ORIGINATION FORM

Proposed Revisions to a Standard Plans Index
(Please provide all information — Incomplete forms will be returned)

Index Number: 425-040

Index Title: Gutter Inlet Type S

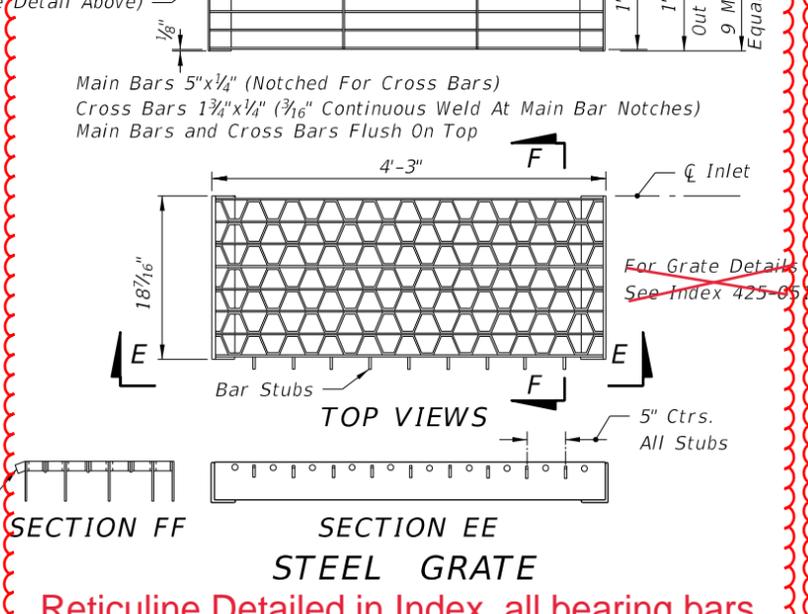
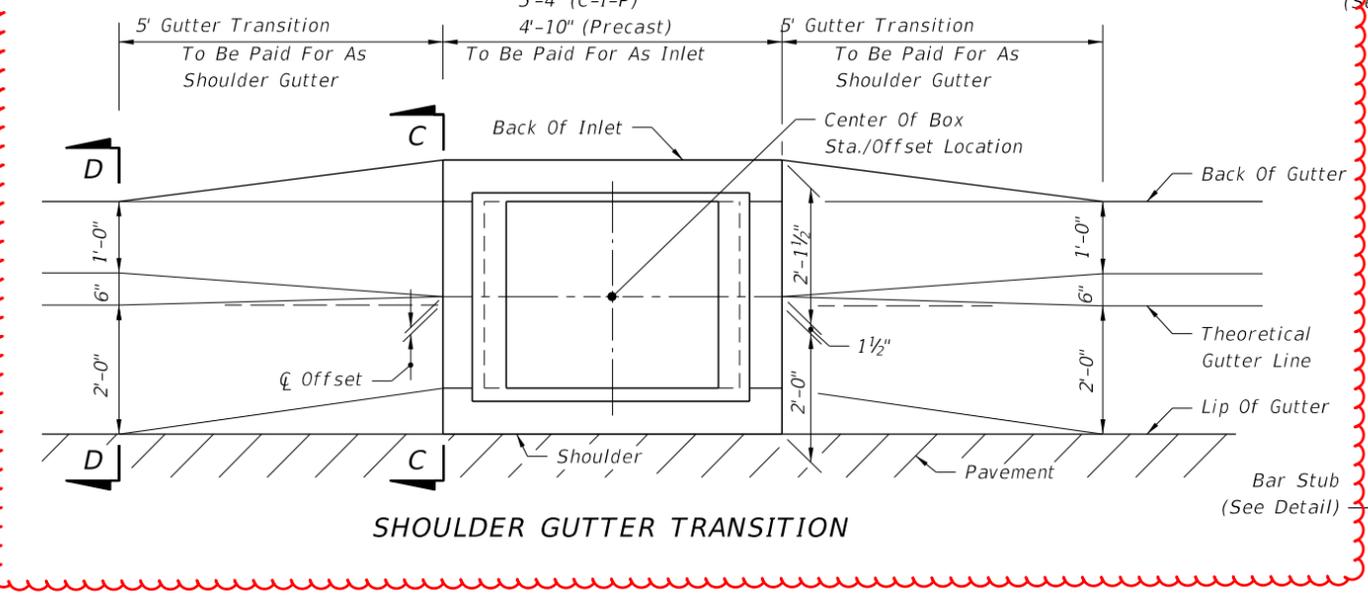
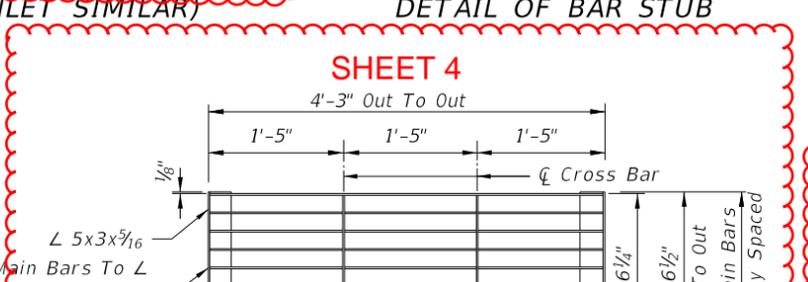
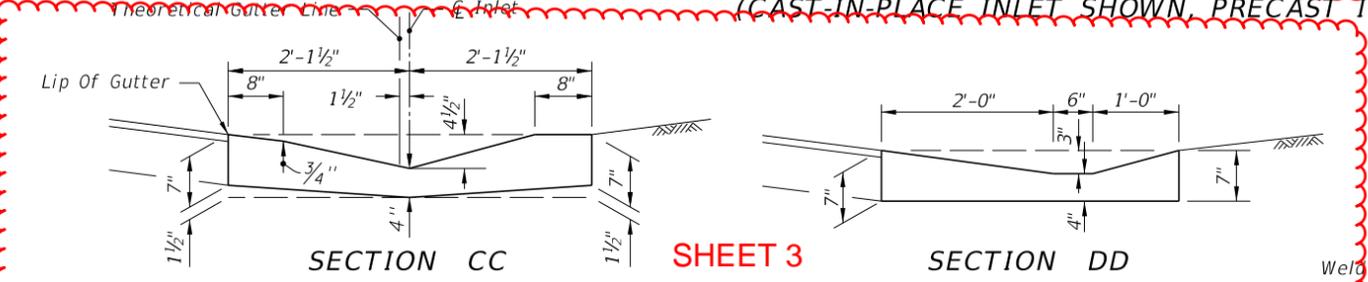
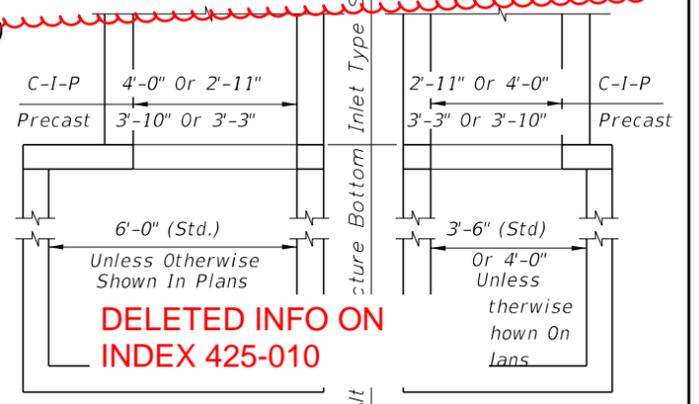
Note: Recommended sizes **MOVED TO SPI** te pipe. Sizes for other types of pipe must be verified for fit in accordance with Index 425-001. For larger pipe see bottom detail below and Index 425-010.

NOTE: Alt. B Structure Bottom Only. See Index 425-010 for structure bottom details and hole reinforcement.

NEW SHEET 3

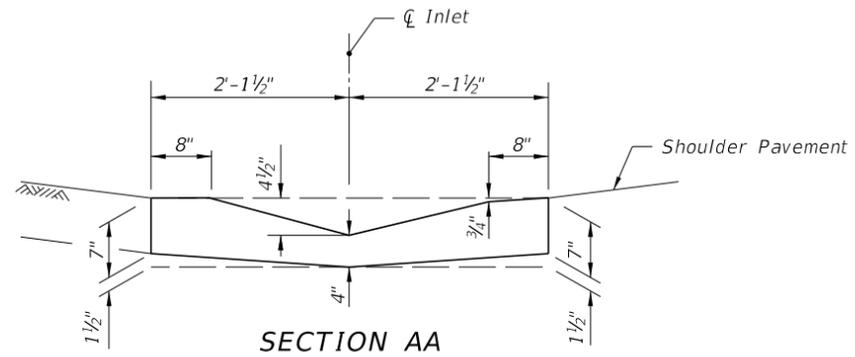
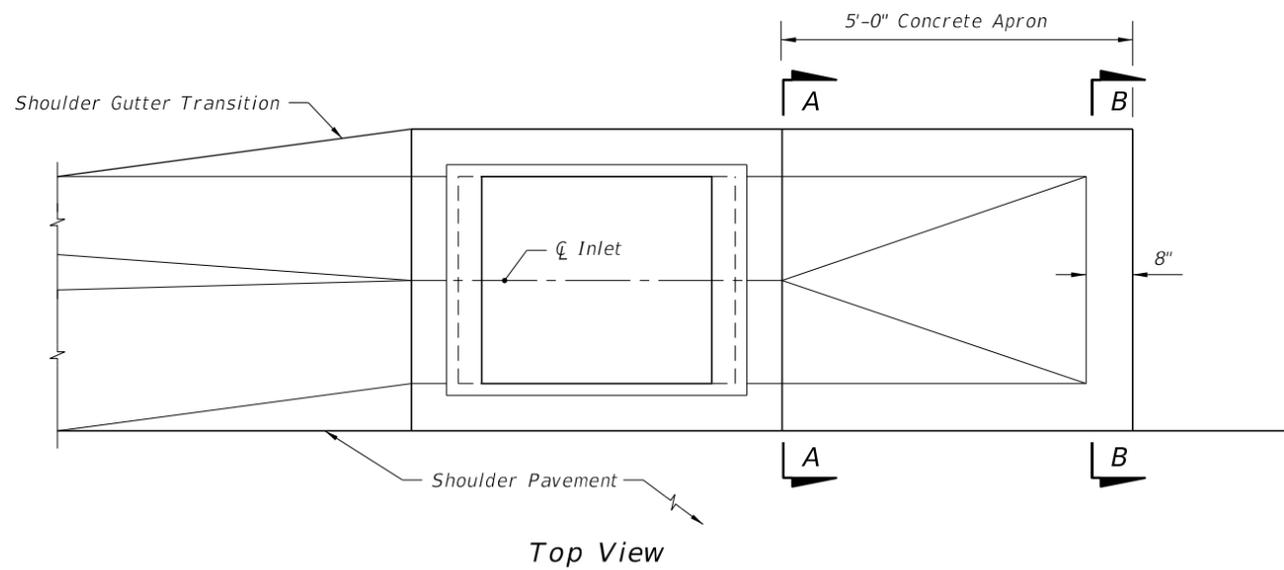
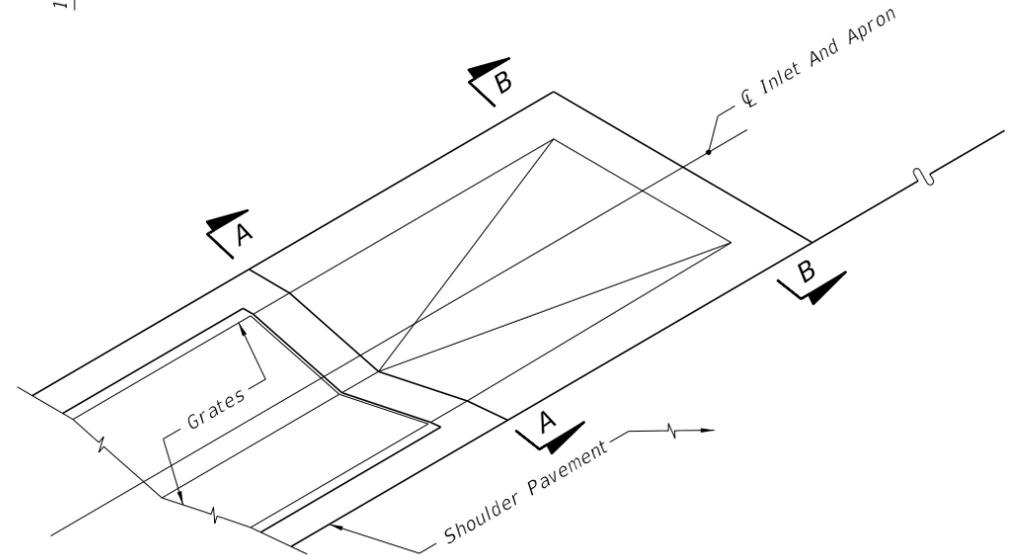
Apron To be Constructed At The Most Downstream Inlet In A Run Of Shoulder Gutter
CONCRETE APRON AT TERMINAL INLETS

NEW SHEET 5

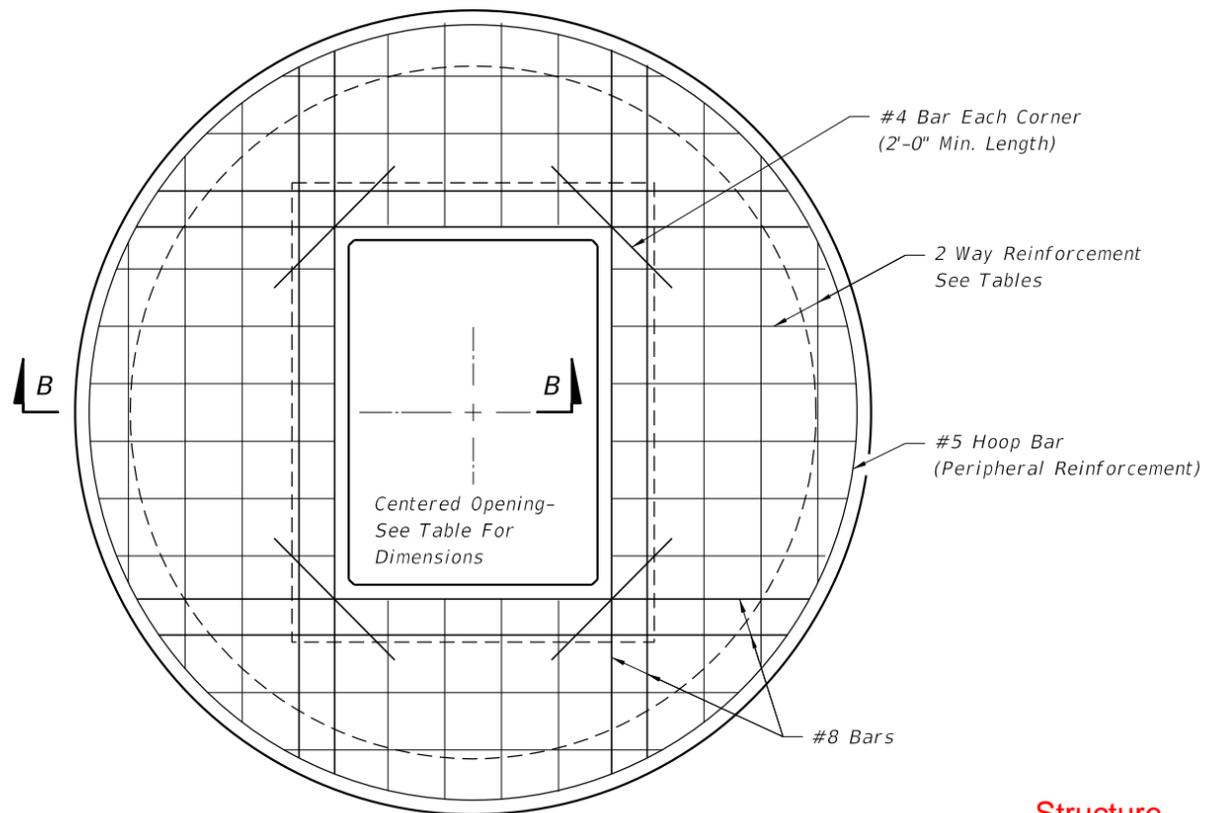
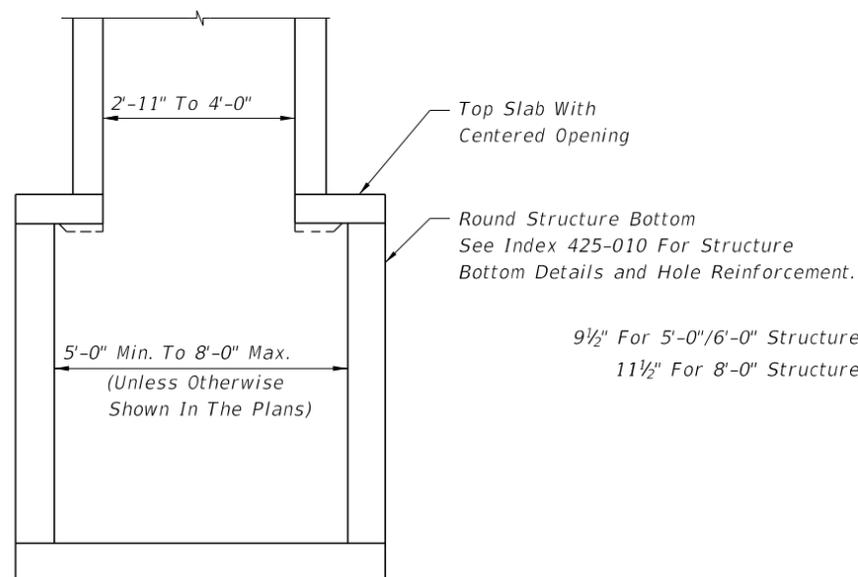
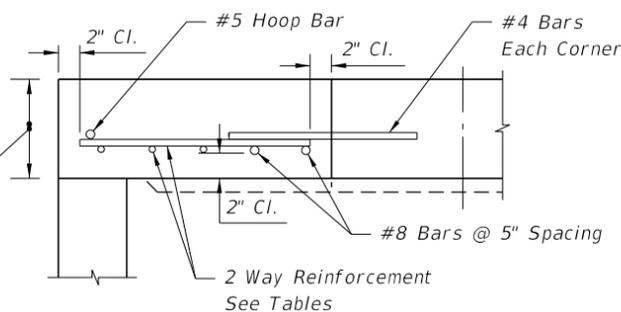
Added Ref. Note to see Index 425-010

ALT. A STRUCTURE BOTTOM FOR INLET TYPE S

STEEL GRATE DETAILS

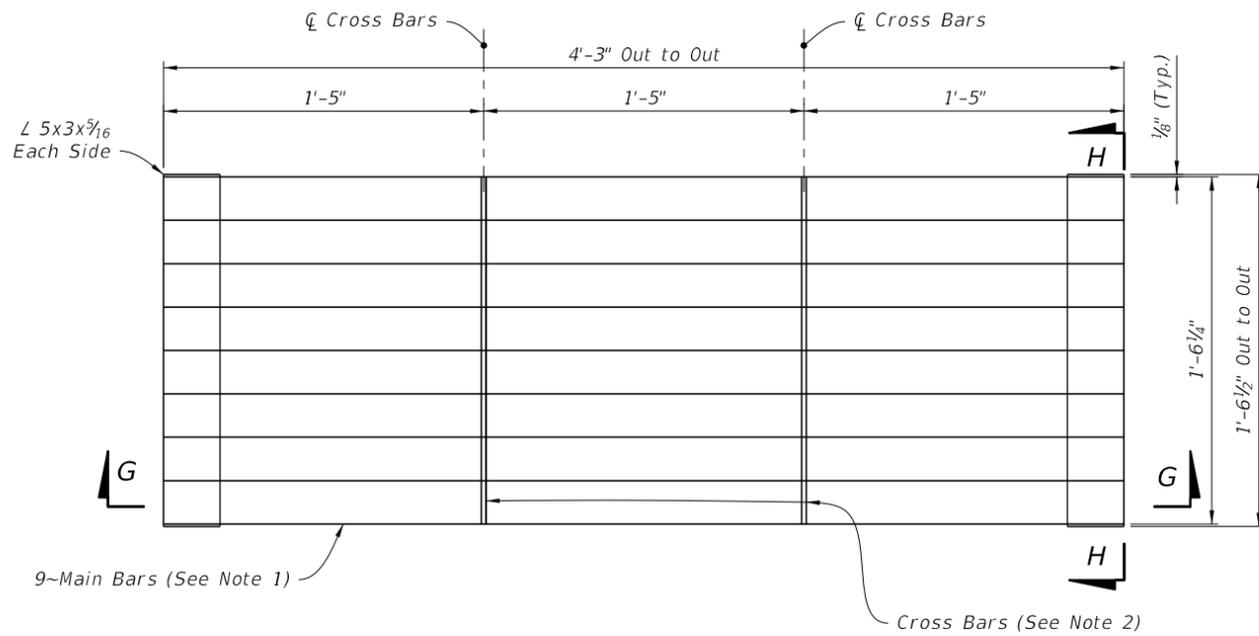
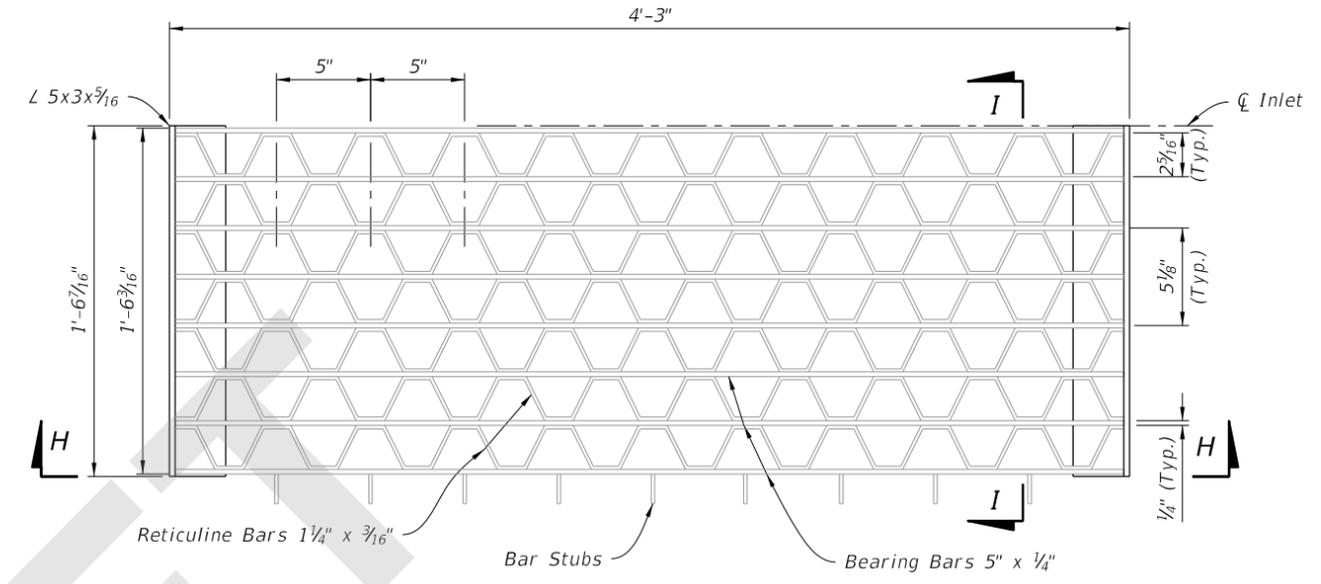
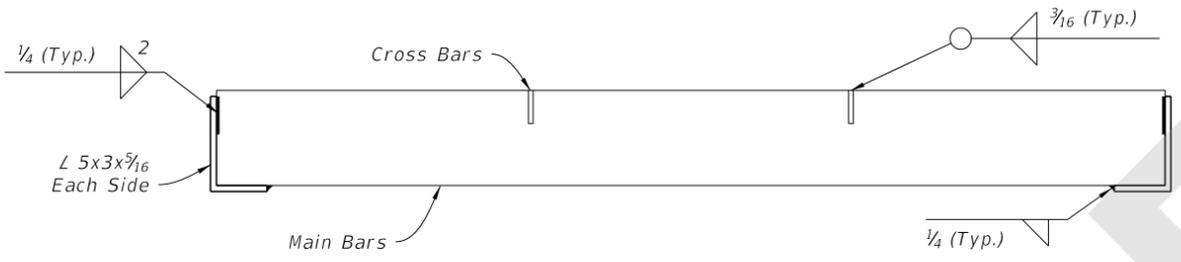
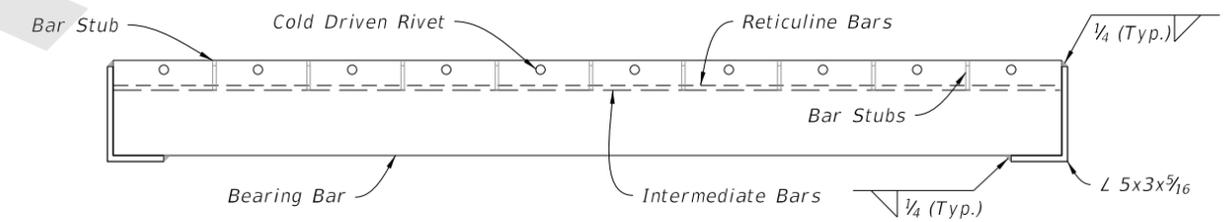
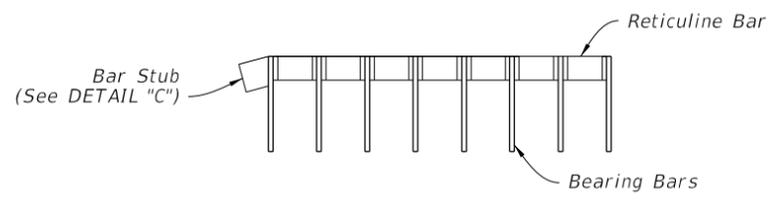
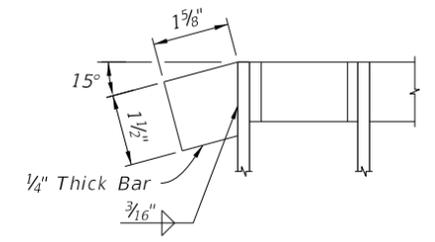
Deleted Intermediate Bars from Reticuline Grate, changed all bars to Bearing Bars.

Reticuline grate changed to all bearing bars to support heavy traffic loads (i.e. HL-93 loadings). With possibility for full roadway width travel in emergencies, these grates could see repeated traffic loading.

1. Main Bars are 5"x1/4", notched for Cross Bars, and spaced equally apart.
2. Cross Bars are 1 3/4"x1/4" and continuously welded at Main Bar Notches.
3. Main Bars and Cross Bars are flush on top.
